PROJECT NUMBER: SP2020-011
PROJECT NAME: Amended Site Plan for Channell Commercial Corporation
SITE ADDRESS/LOCATIONS: 1700 S JOHN KING BLVD

CASE CAPTION: Discuss and consider a request by Mark W. Pross of Pross Design Group, Inc. on behalf of Ed Burke of Channell Commercial Corporation for the approval of an Amended Site Plan for an existing industrial building on an 18.762-acre parcel of land identified as Lot 2, Block A, Channell Subdivision Addition, City of Rockwall, Rockwall County, Texas, zoned Light Industrial (LI) District, situated within the SH-205 By-Pass Overlay (SH-205 BY OV) District, addressed as 1700 John King Boulevard, and take any action necessary.

06/25/2020: SP2020-011; Amended Site Plan for Channell Commercial Corp.
Please address the following comments (M= Mandatory Comments; I = Informational Comments)

TO: Planning and Zoning Commission
FROM: Ryan Miller, *Director of Planning and Zoning*
DATE: July 14, 2020
SUBJECT: SP2020-011; *Amended Site Plan for Channell Commercial Corporation*

1 SITE PLAN
SCALE: 1"=60'-0"

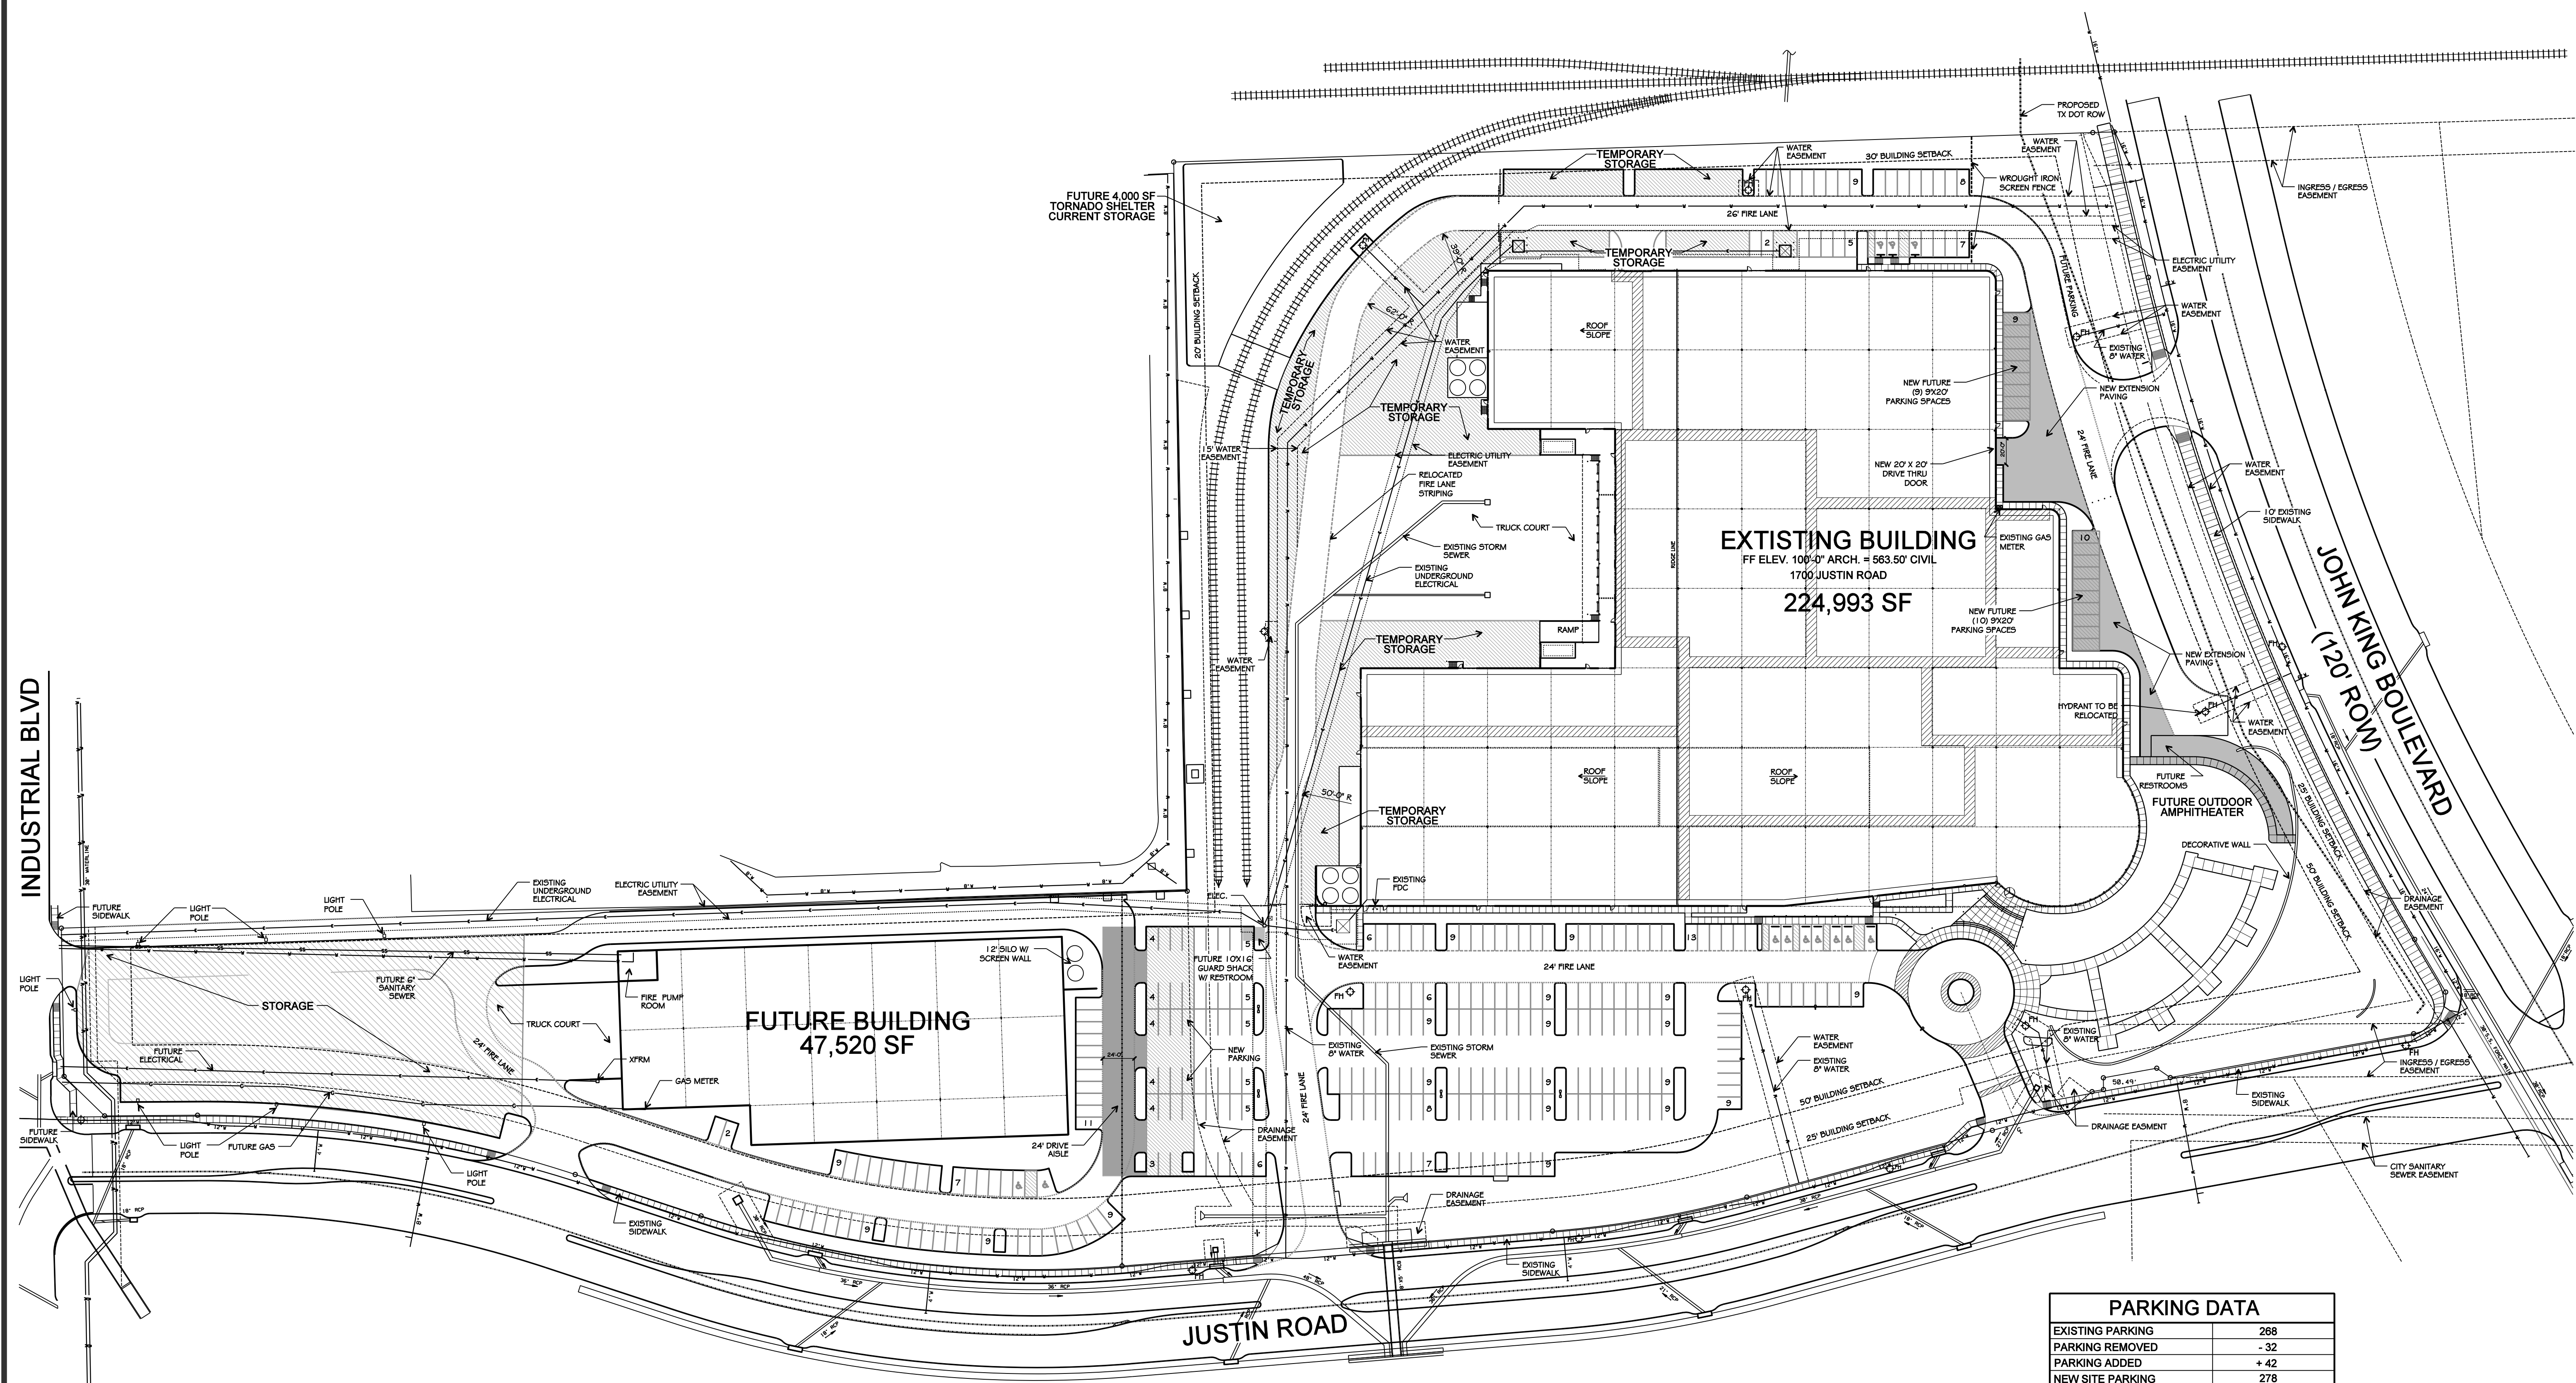
M.10 Site Plan. Please make the following clarifications on the site plan to ensure staff can properly review this project and convey all of the required elements to the City's boards and commissions (§03.04, Art. 11, UDC):

- 1) Remove building footprint of future building as this is not being considered with this site plan amendment. (§03.04.B, Art. 11, UDC)
- 2) Indicate the location and total square footage of the proposed storage area. (§03.04.B, Art. 11, UDC)

- 5) Indicate location of all Fire Hydrants. (§03.04.B, Art. 11, UDC)
- 6) Update the parking table indicating the total number of required parking spaces and remove the parking table listed as 'Future Bldg Parking Data Summary'. This site is not considering the future building, only the addition of parking spaces to the existing building. (§05.01, Art. 06, UDC)

- 7) Provide a label for all Firelane to indicate "24-ft Firelane, Public Access, Drainage, & Utility Easement", as appropriate for existing and proposed. (§03.04.B, Art. 11, UDC)

- 9) Indicate the type and depth of the paving material and provide a detail or cut-sheet. All required parking and loading areas shall be constructed of concrete, but may have a surface treatment of brick, stone or other similar material. Must meet Engineering standards of design. (§03.02, Art. 06, UDC)

SITE LANDSCAPE PLAN WEST

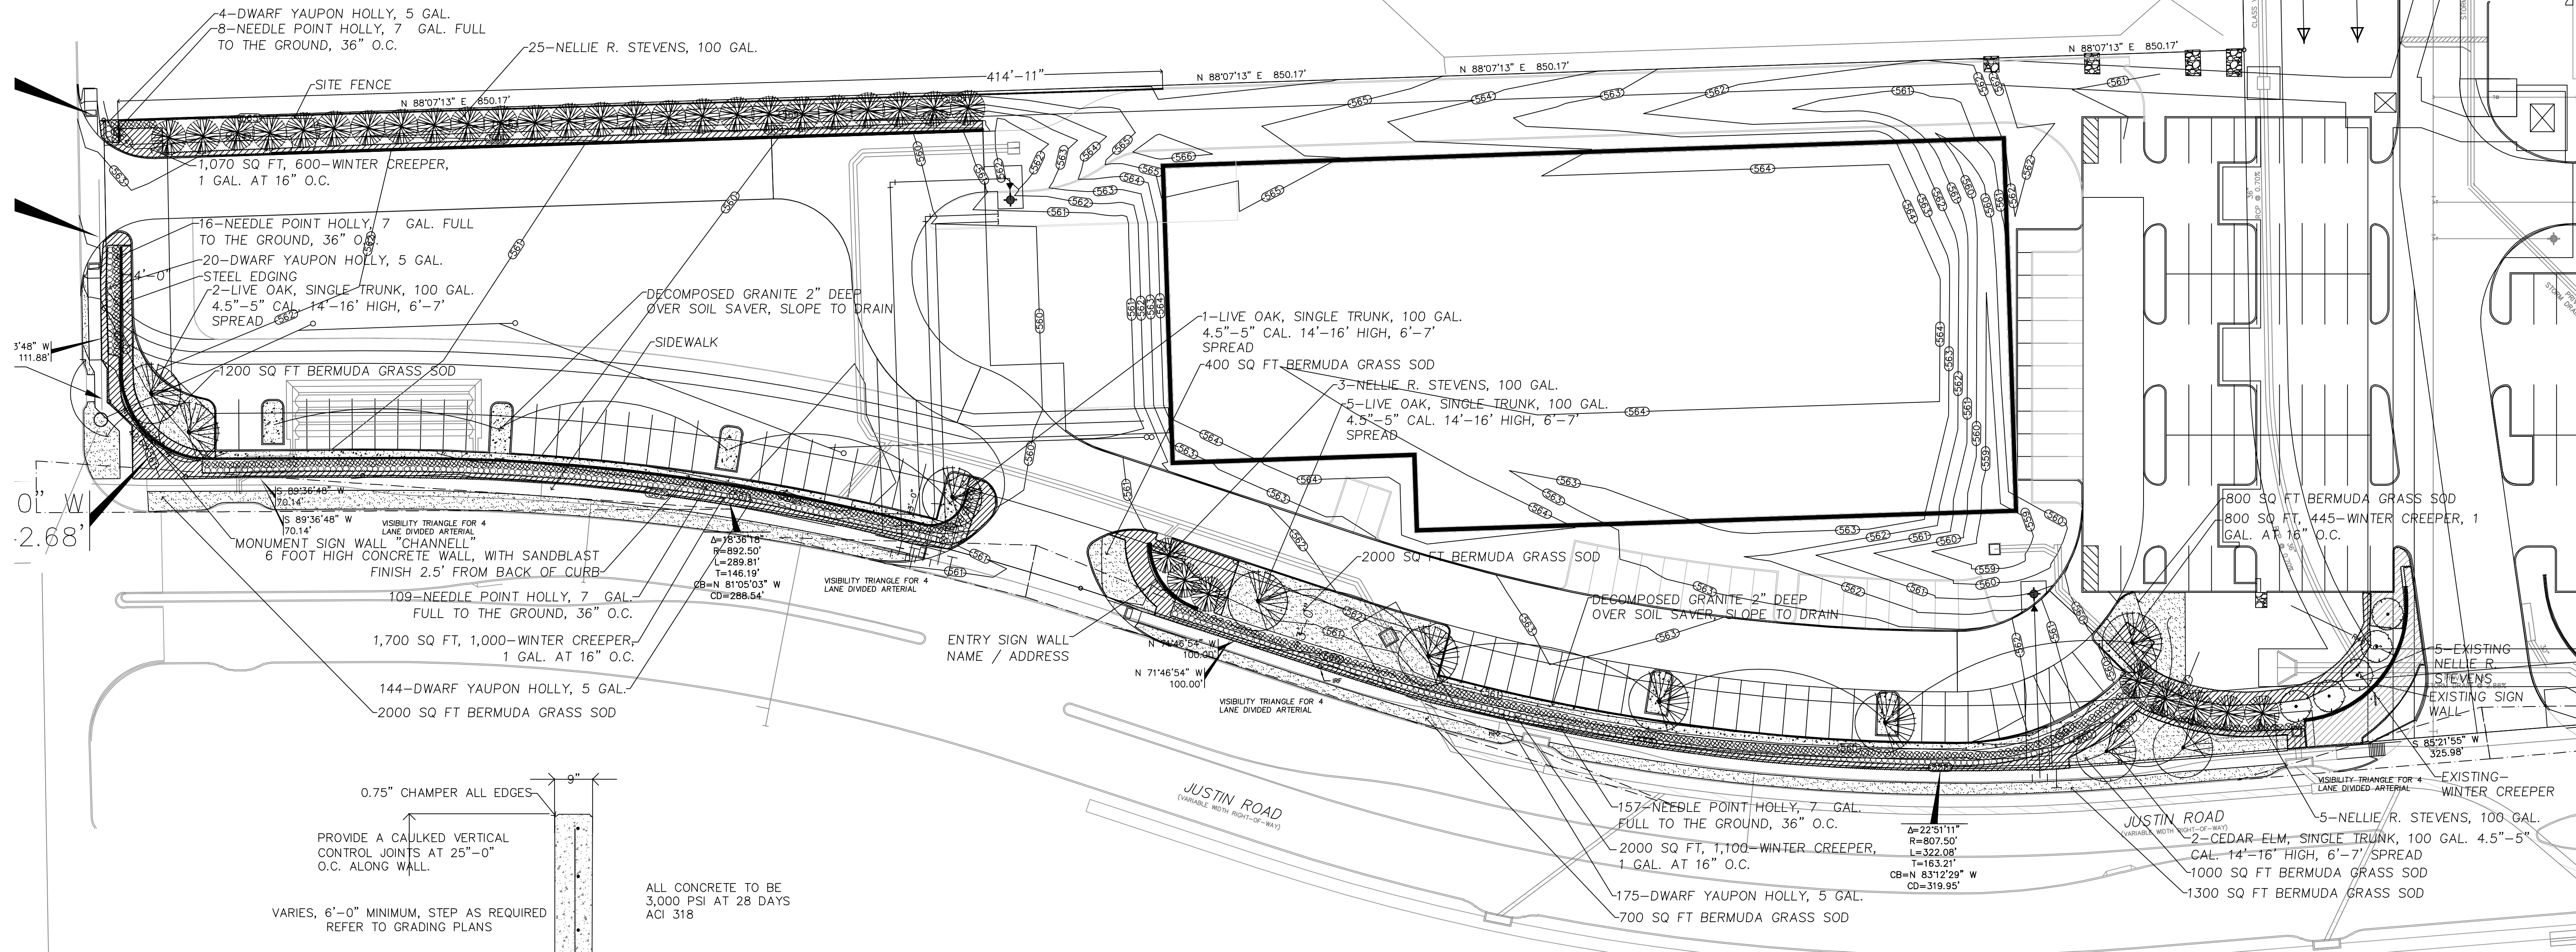
M.11 Landscape Plan. Please make the following clarifications and changes to the landscape plan to ensure staff can properly review this project and convey all of the required elements to the City's boards and commissions (Sec. 2, Art. 08, UDC):

- 1) Provide the necessary landscape screening associated with the outside storage requirement on the site plan along Justin Road (i.e. canopy trees on 20-foot centers). (§01.05.E, Art. 05, UDC)

- 2) Indicate the locations and dimensions of the required landscape buffers along Justin Road. (§05.01, Art. 08, UDC)
- 3) Provide a label for all Firelane to indicate "24-ft Firelane, Public Access, Drainage, & Utility Easement", as appropriate for existing and proposed. (§03.04.B, Art. 11, UDC)

- 4) Delineate and label a minimum 10-foot landscape buffer strip along Justin Road. (§05.01.B.1, Art. 08, UDC)
- 5) Provide trees in the required street landscape buffer in numbers equal to one (1) canopy tree and one (1) accent tree for every 50 feet of street frontage. Verify and provide the necessary amount of trees within the landscape buffer along Justin Road. (§05.01, Art. 08, UDC)

- 6) Add 'Notes' to landscape plan indicating the following:
 - a. Trees must be planted at least five (5) feet from water, sewer and storm sewer lines. (§05.03.E, Art. 08, UDC)
